**UNIFORM STANDARD DRAWINGS
CLARK COUNTY AREA**

VOLUME I - YEAR 2008 REVISIONS

| | | DATE 6-12-08 | DWG. NO. 503AB |

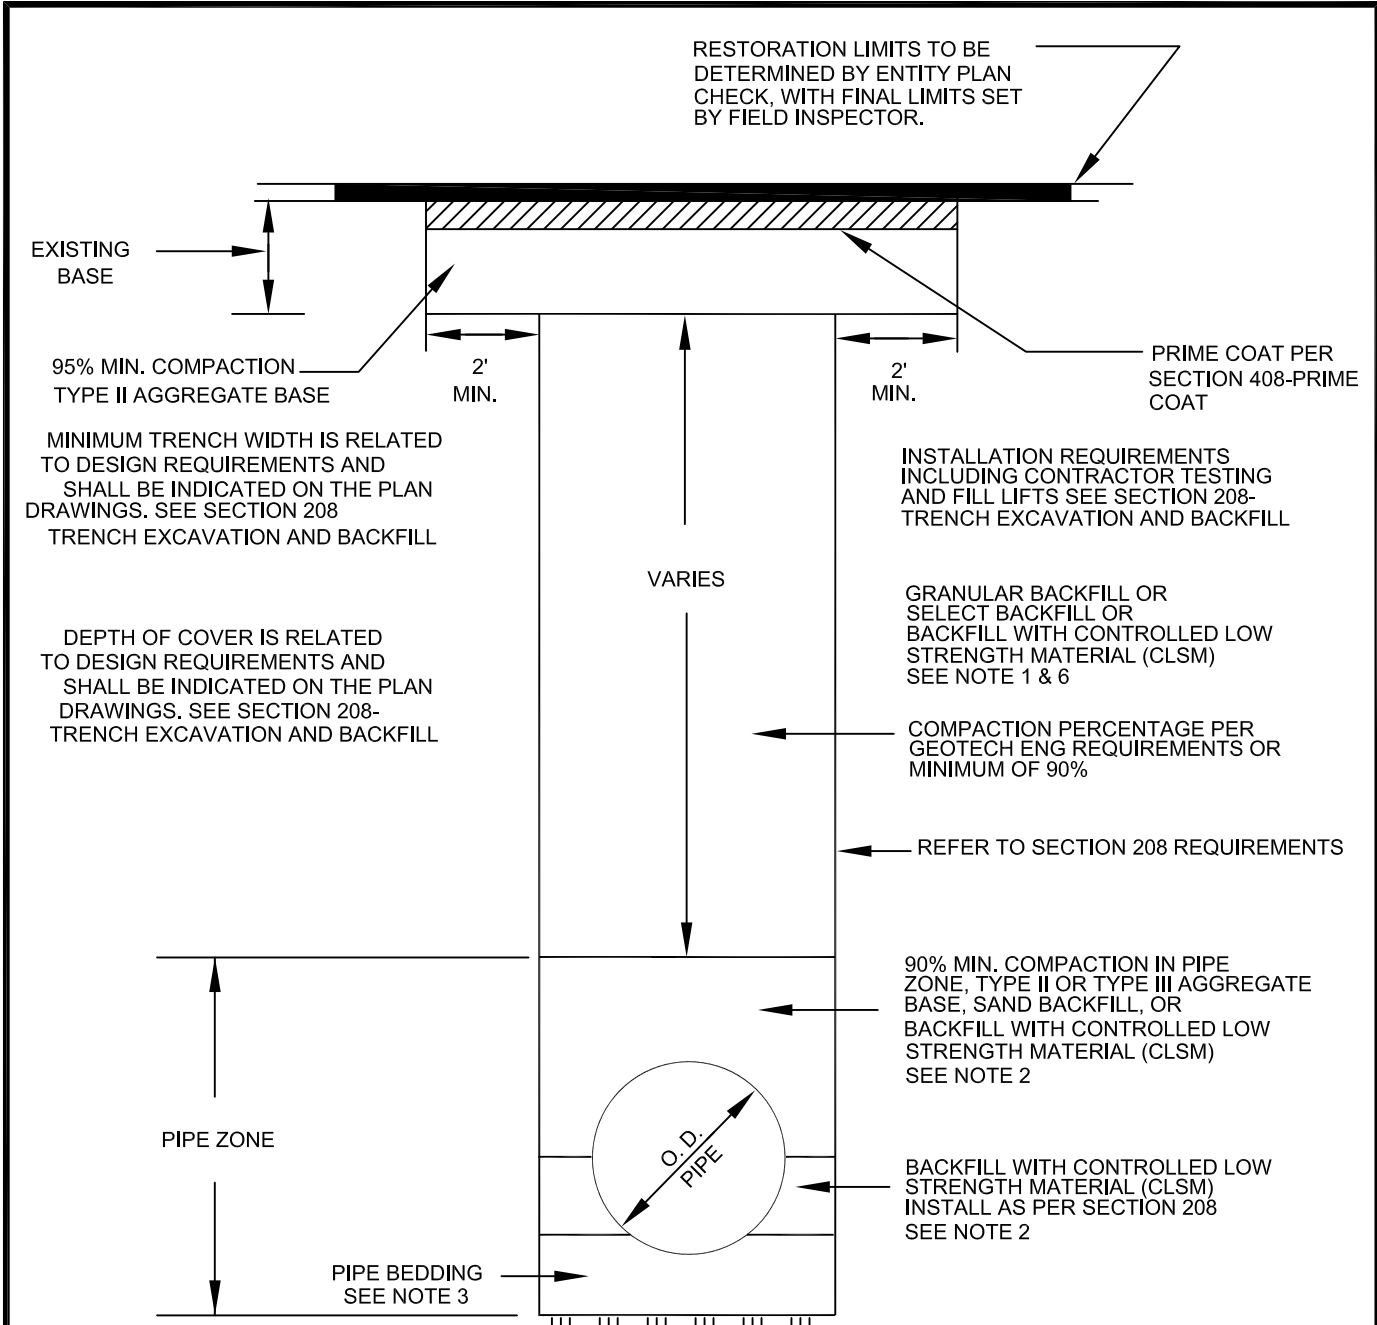
| 503AB | "Method For Rigid Pipe Trench Backfill – Paved Areas" | Addition to incorporate new Standards from the Recommendations of the recent pavements cut study and trench working group. | 07/01/08 |

| | | DATE 6-12-08 | DWG. NO. 504 |

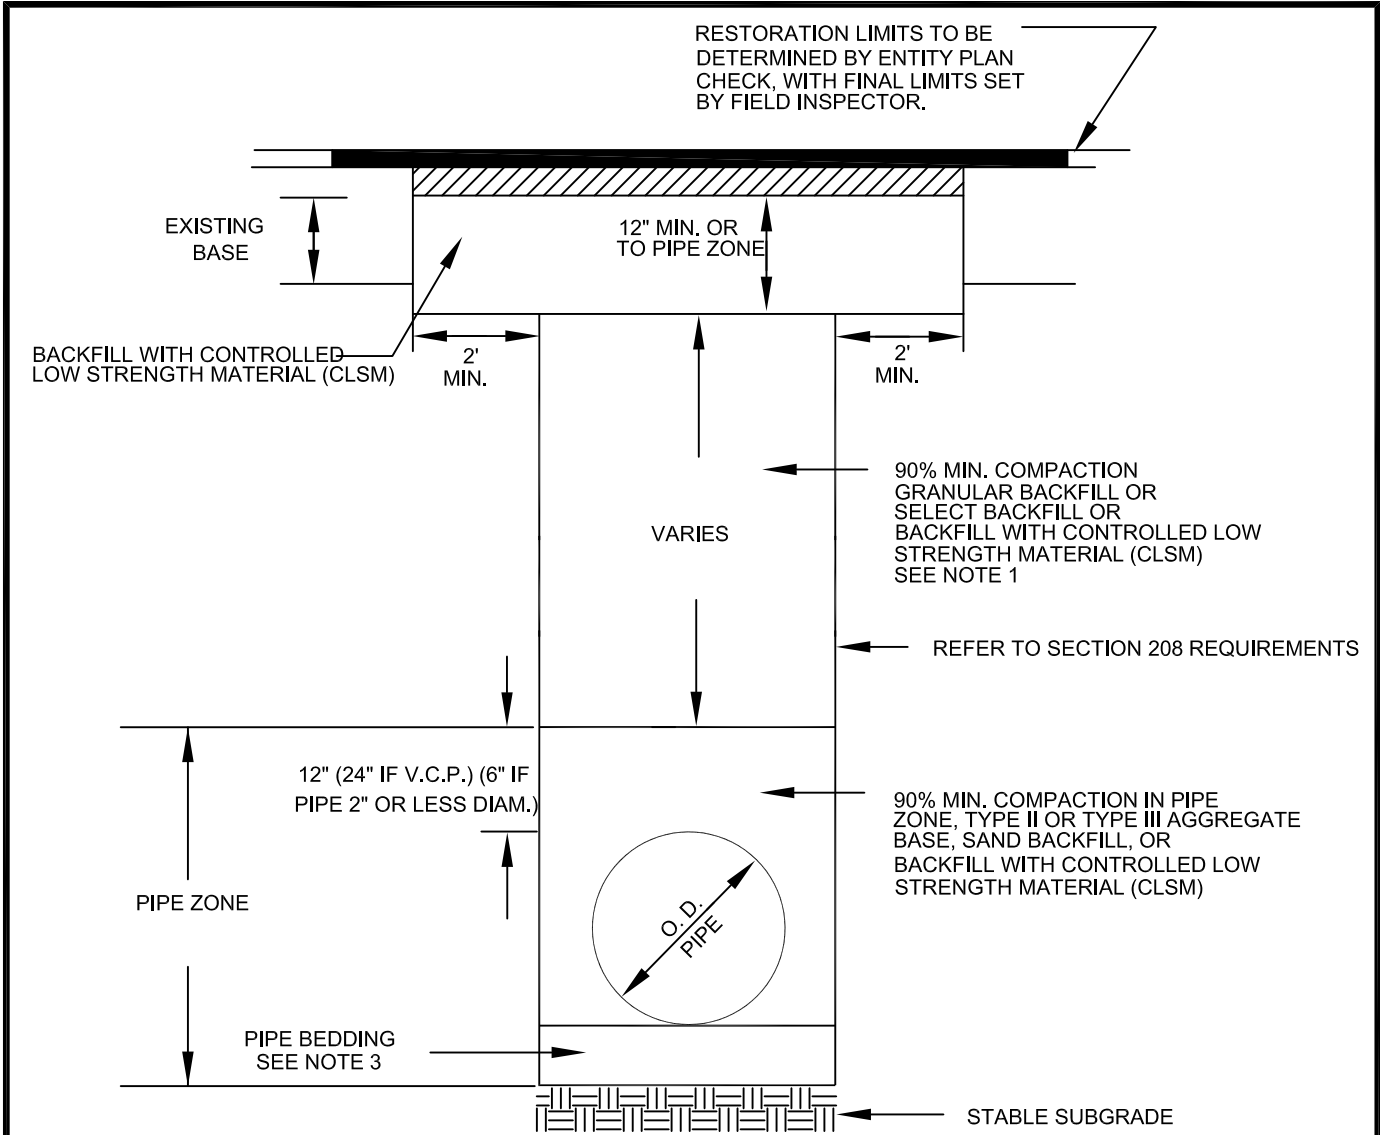
| 504 | "Trench Backfill with Controlled Low Strength Material (CLSM) Paved Areas (Streets Greater than 60' R/W)" | Revision to clarify the cross section of the permanent asphalt patch. | 01/01/08 |
| 504 | "Trench Backfill with Controlled Low Strength Material (CLSM) Above Pipe Zone In Paved Areas (Streets Greater than 60' R/W)" | Revision to incorporate new Standards from the Recommendations of the recent pavements cut study and trench working group. | 07/01/08 |
